Response to NCDEQ Comments on the Brevard Conceptual Remedial Action Plan

Soil Cover Verification
Response to NCDEQ Comments
Brevard Site
Cedar Mountain, North Carolina

Figure 3
(Revised RAP Figure 5-3)

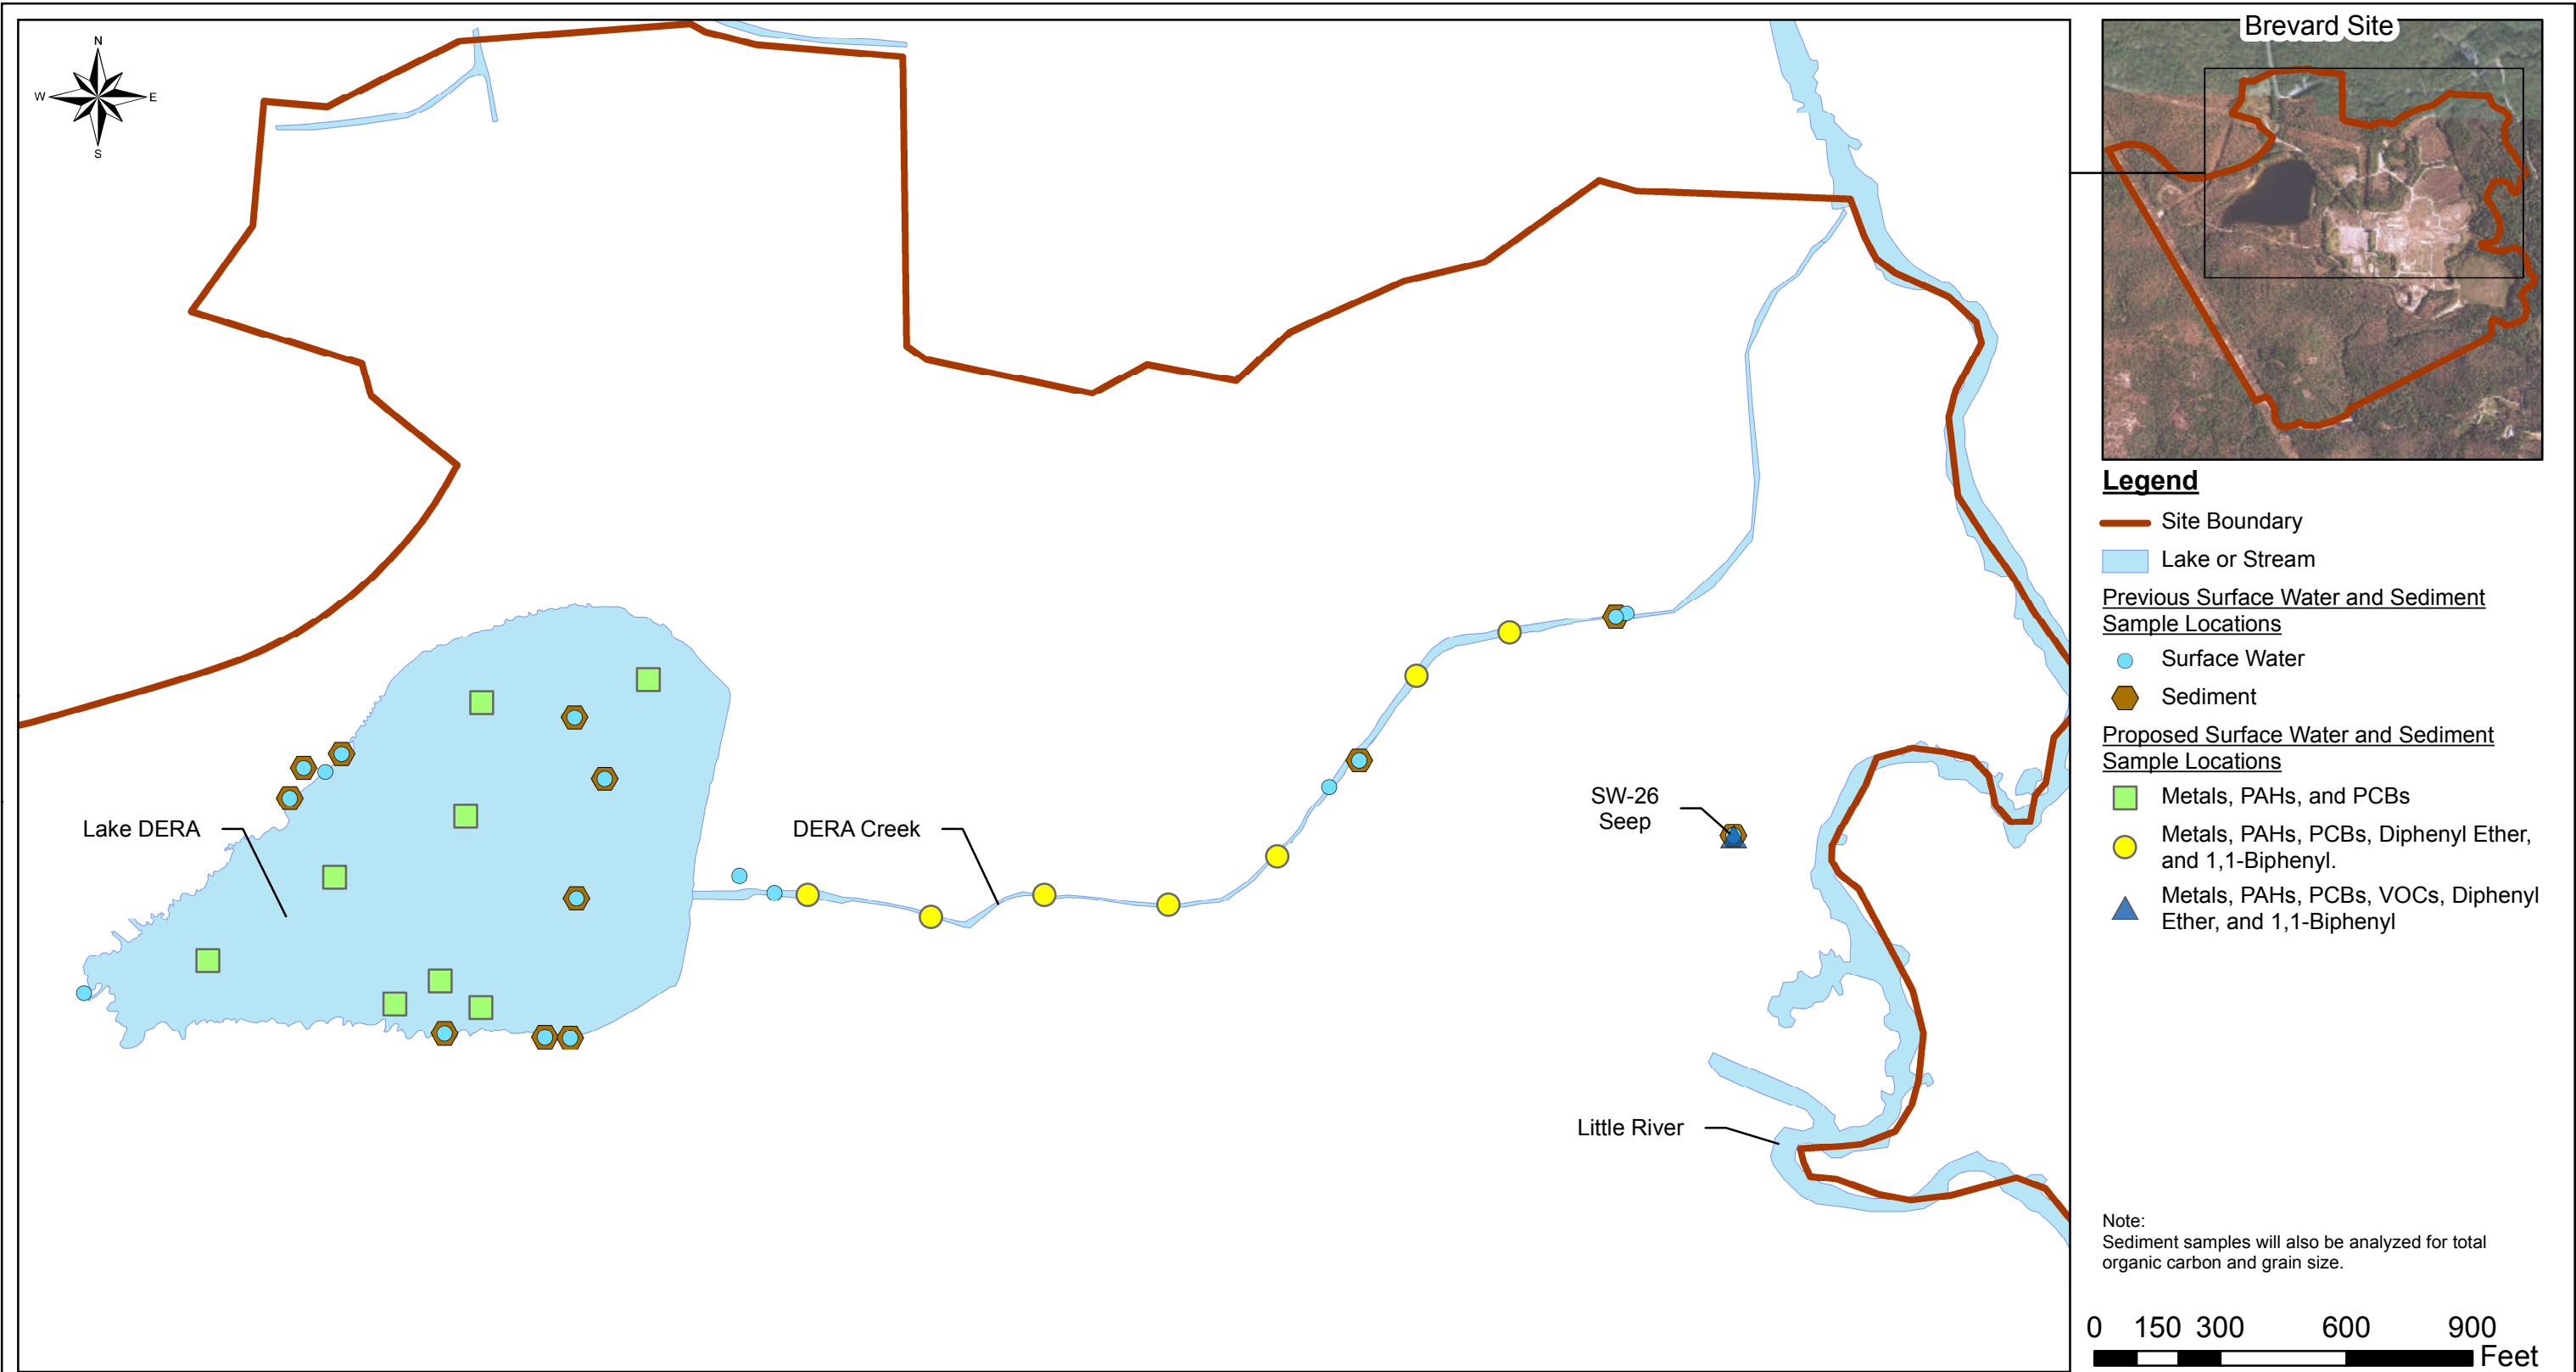
18.	<p>Section 7.6.2 – see comment 6.</p>	<p>Before the RAP is submitted to NCDEQ, the in-text table in Section 7.6.2 will be updated to change the designation for AOC F from a No Dig Area to a Test Before Dig Area (Require that soil is sampled prior to any excavation activities). Figure 5-3 will also be updated to reflect the change (see Figure 3 [Revised RAP Figure 5-3]).</p>
